**WRITTEN REPRESENTATIONS REGARDING THE A14 CAMBRIDGE TO
HUNTINGDON IMPROVEMENT SCHEME DEVELOPMENT CONSENT ORDER 201 [...]**

PLANNING INSPECTORATE REFERENCE NO TR010018

WRITTEN STATEMENT OF LINTONS FARM, HILTON, CAMBS

DATE OF STATEMENT 12 JUNE 2015

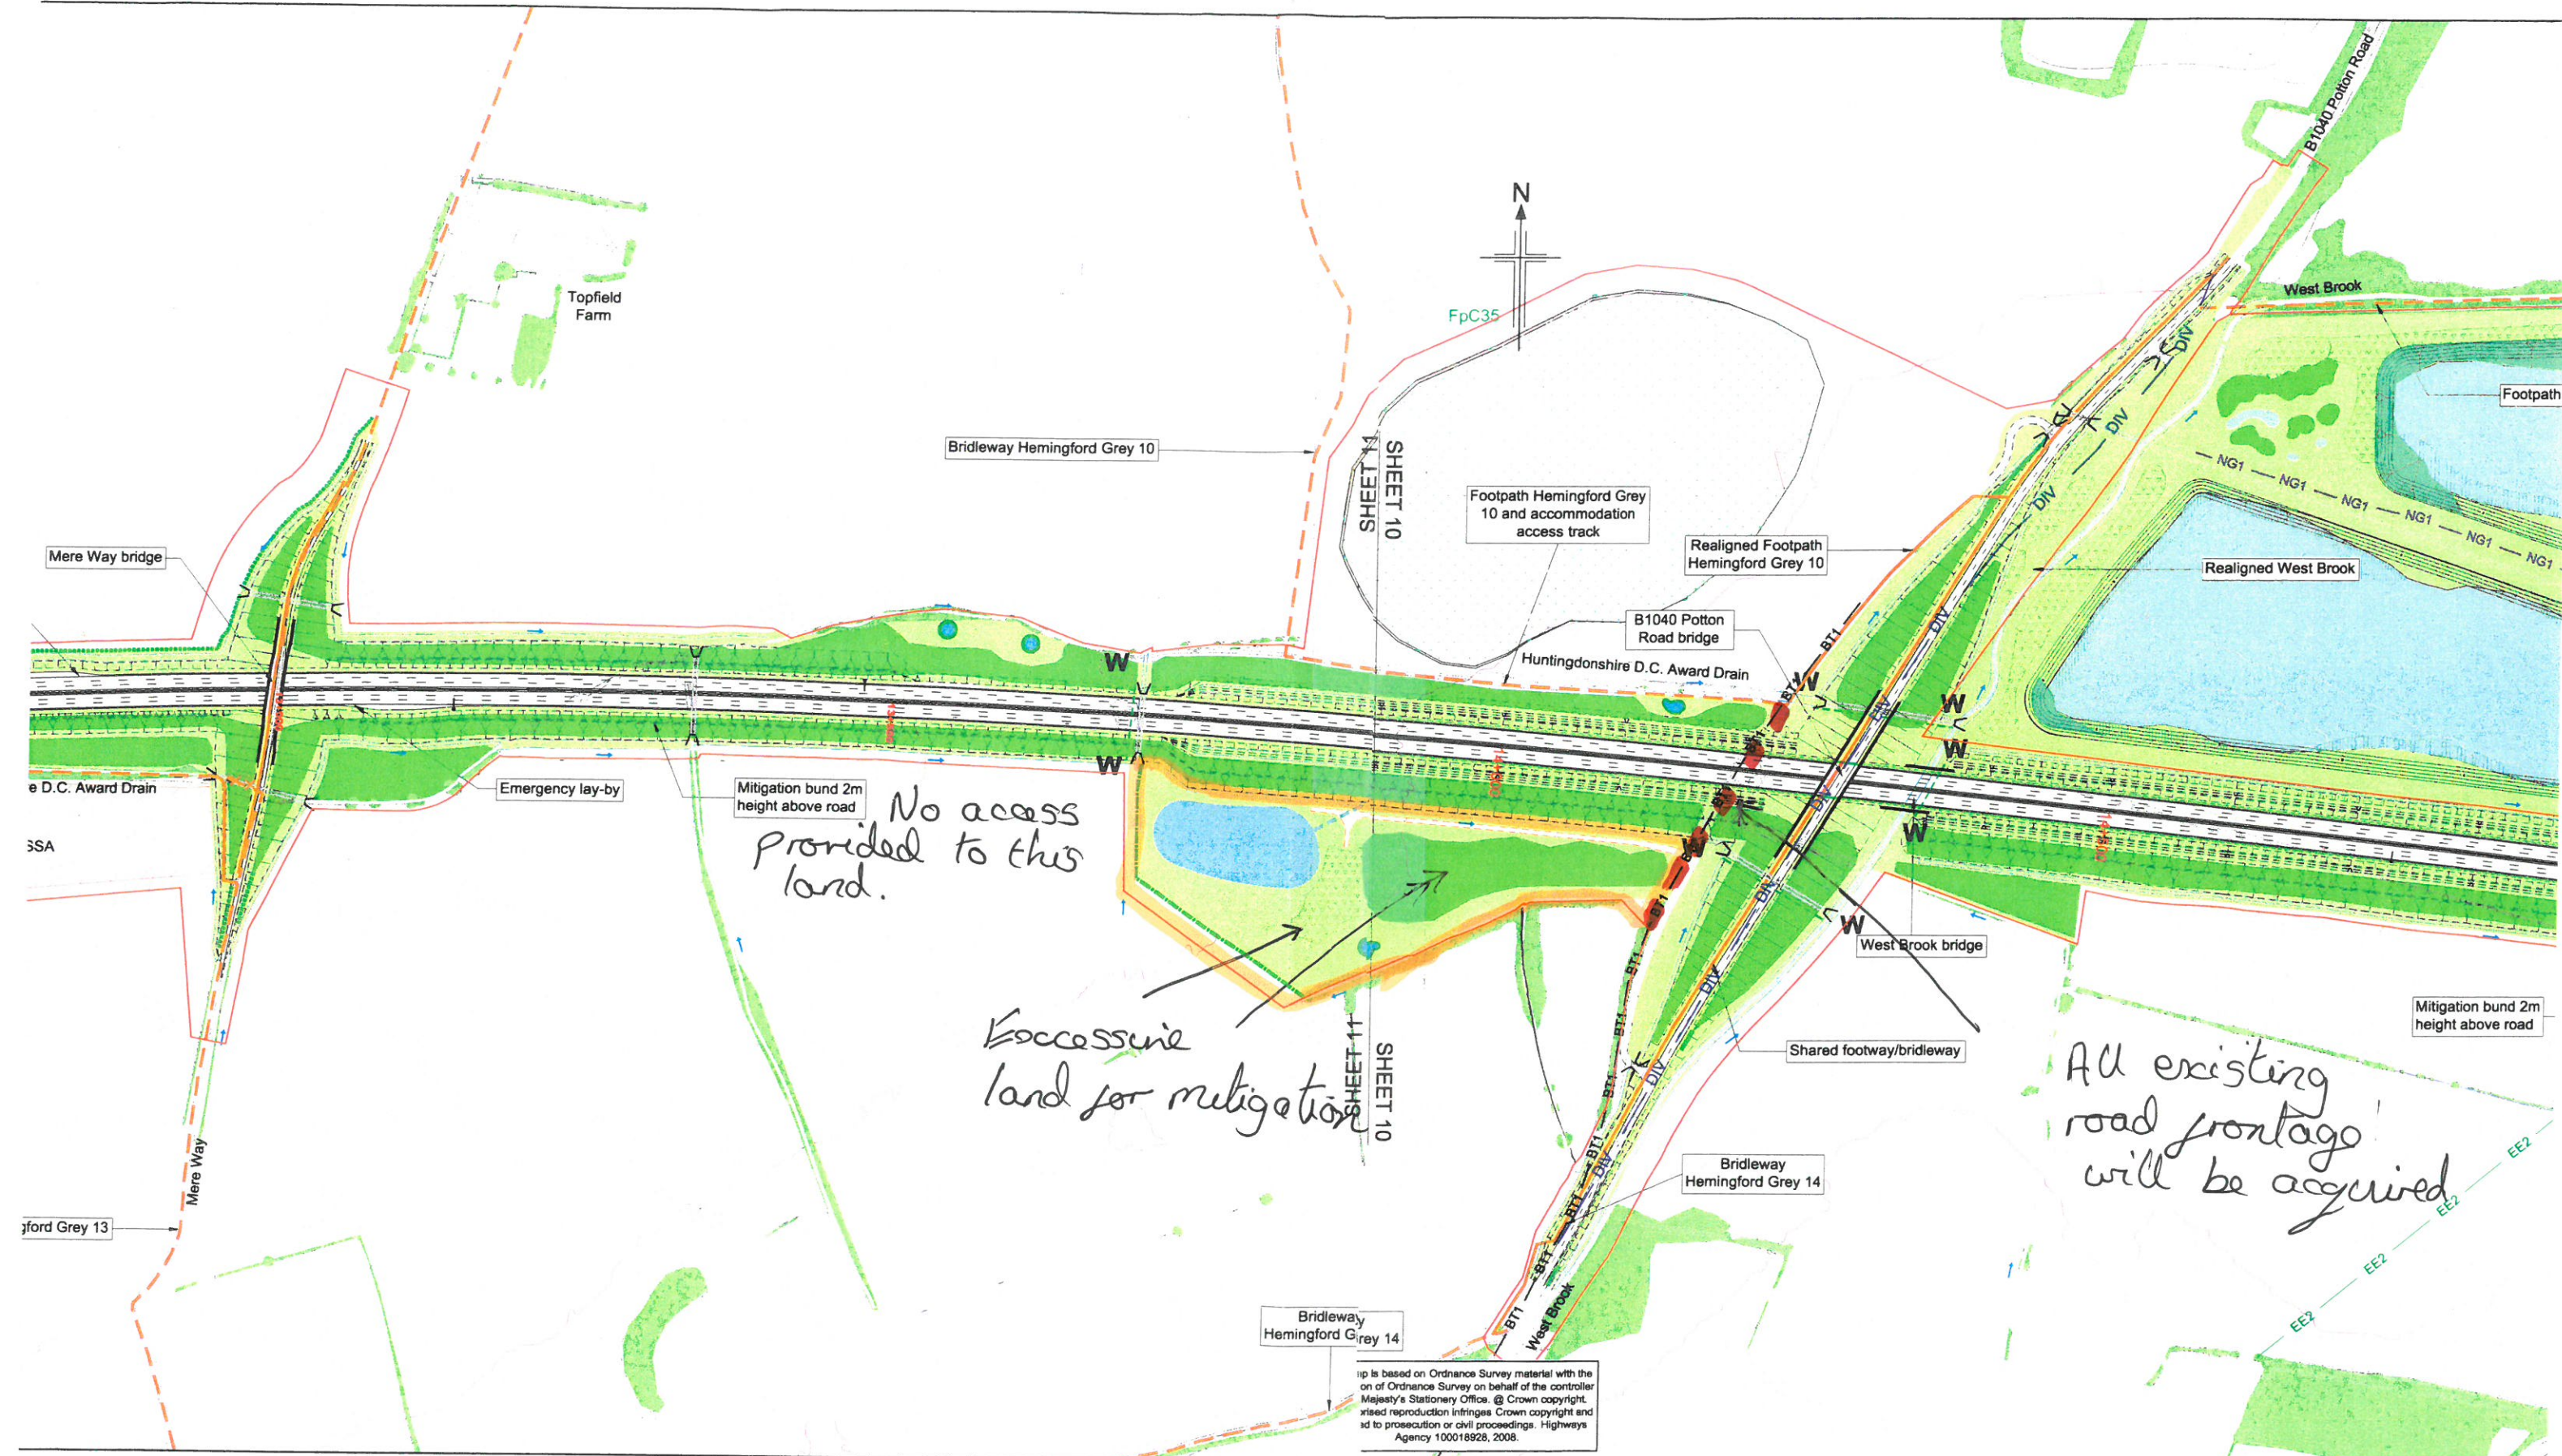
The Applicant has taken extensive unnecessary land for an attenuation pond with a further area four times the size of the pond, taken for environmental mitigation purposes. This pond could easily be re-located and significantly reduce the amount of land take and associated mitigation works. See attached map.

The proposed six lane road requires approximately 25 metres width yet land to be acquired is 110 metres wide, An excessive waste of good agricultural land and tax payers money. The additional land will have minimal effect on the road's environmental impact.

There has been inadequate reassurance that a suitable replacement vehicular access for modern day agricultural machinery is being provided to the retained land which extends both sides of the new road following compulsory acquisition of almost the entire existing road frontage. See attached map.
